ORANGE COUNTY WATER DISTRICT
APPLICATION TO APPROPRIATE
SANTA ANA RIVER WATER

Final Program Environmental Impact Report
Response to Comments
SCH # 2002081024

Prepared for:
Orange County Water District

July 2006

OCWD, 202291
Figure 2-8
 Lower Santa Ana River Watershed
 with Biological Study Reaches
 (Revised)

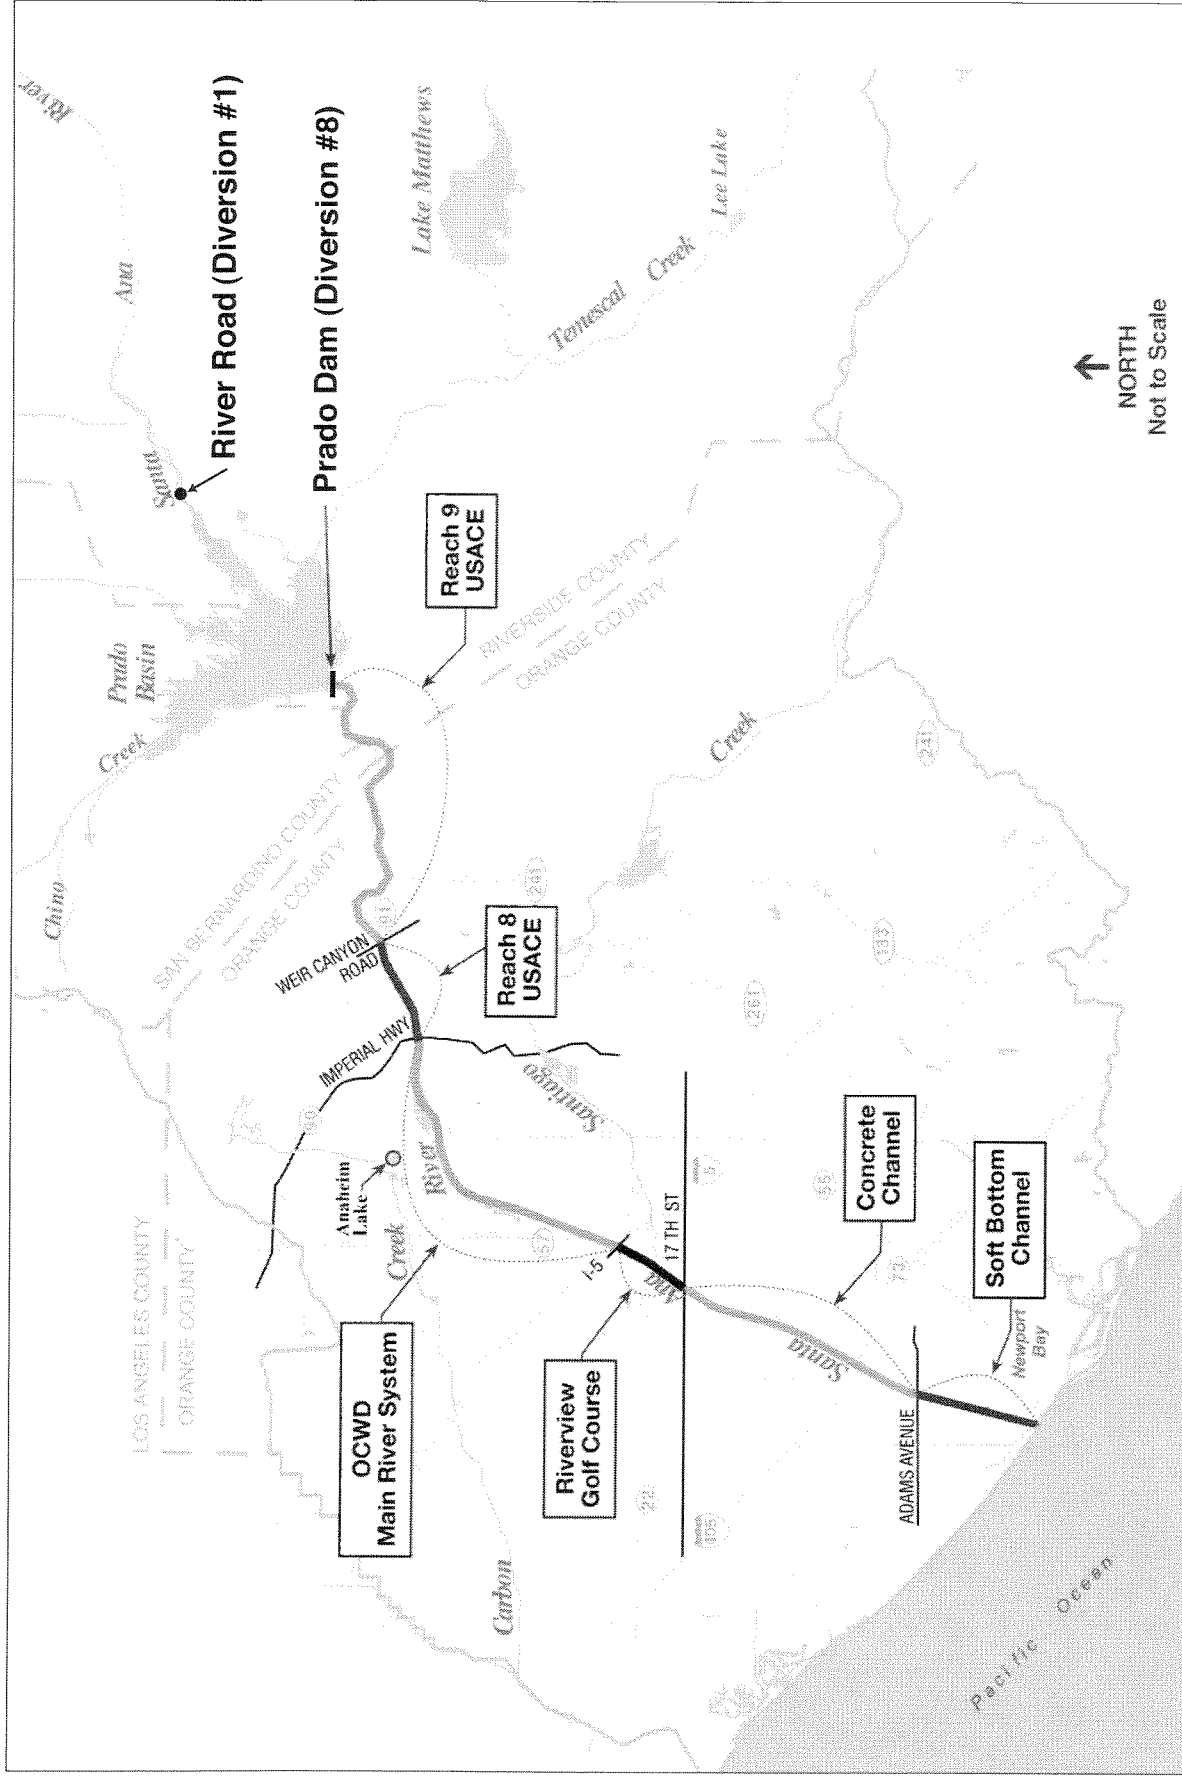
The comment states that the project description does not identify which points of diversion are used for each project. As shown in the revised Figure 2-8, Diversion #1 at River Road above Prado Dam diverts up to 150 cfs out of the SAR to OCWD's Prado Wetlands to reduce nitrate in and improve the quality of river water before being returned to the SAR above Prado Dam. Diversion #8 at Prado Dam represents OCWD's water conservation program with the ACOE to temporarily store water behind the dam and then release it back into the SAR below the dam for groundwater recharge at OCWD's percolation facilities. As shown in the revised Figure 2-9, Diversion Points 2 through 7 below Prado Dam comprise the diversion system that delivers SAR water to OCWD's recharge facilities both within the river bottom itself as well as off-river percolation basins. Table 2-5 of the PEIR identifies points of diversion and notes where the points divert to. Each new recharge project would utilize the existing diversion points from the SAR.

Figure 2-8 has been modified as shown below:

OCWD . 202291
Figure 2-9
 Existing Recharge Facilities and Diversion Points

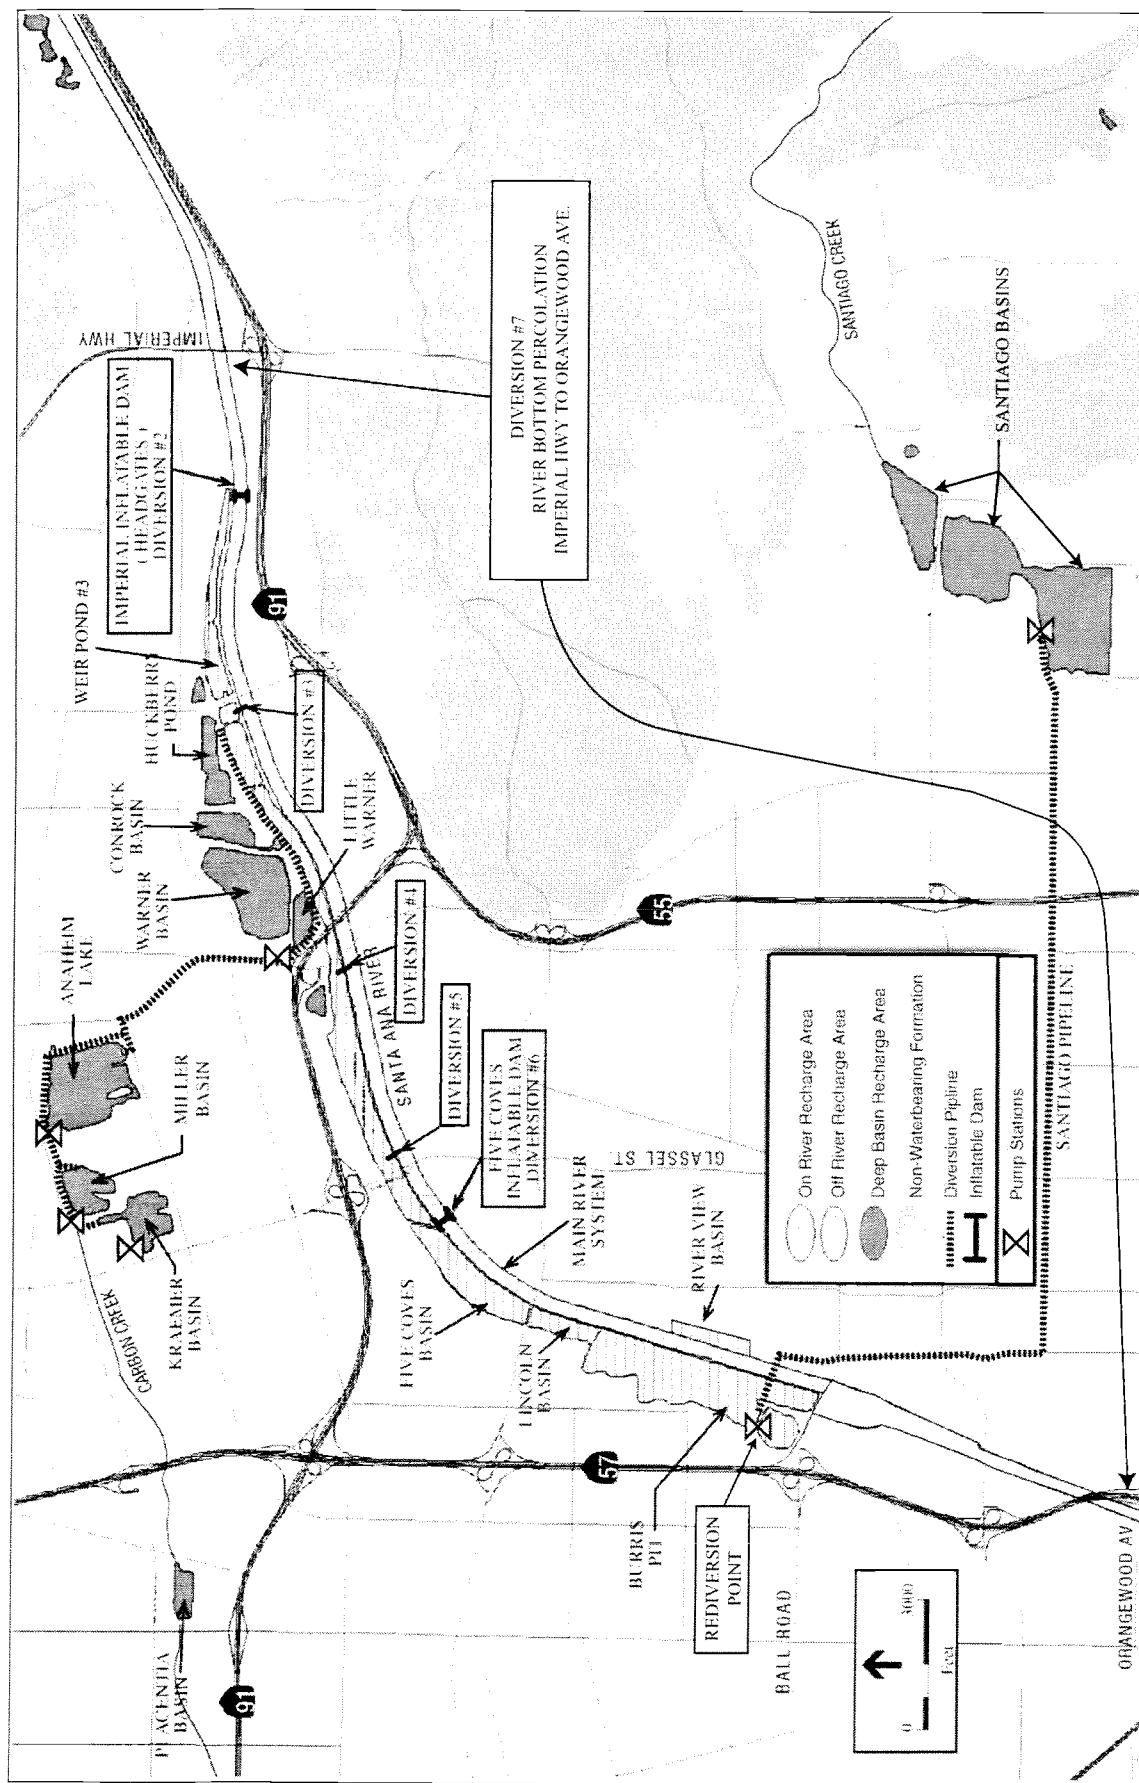
The comment states that Figure 2-9 is inconsistent with the engineering map in the application. Figures 2-8 and 2-9 have been modified to be consistent with the engineering map provided in the application. The revised figures are provided below. Figure 2-9 provides a graphic representation of the points of diversion downstream of Imperial Highway. Figure 2-8 provides a graphic representation of the location of points of diversion upstream of Prado Dam. The exact latitude and longitude of each diversion is correctly identified in Table 3b of the application.

The comment requests that the pipeline leading from Burris Pit to the Santiago Basins and Santiago Creek recharge facility be shown as a point of rediversion. Figure 2-9 has been modified to show that the Santiago Pipeline constitutes a point of rediversion.

Figure 2-9 has been modified as shown below:
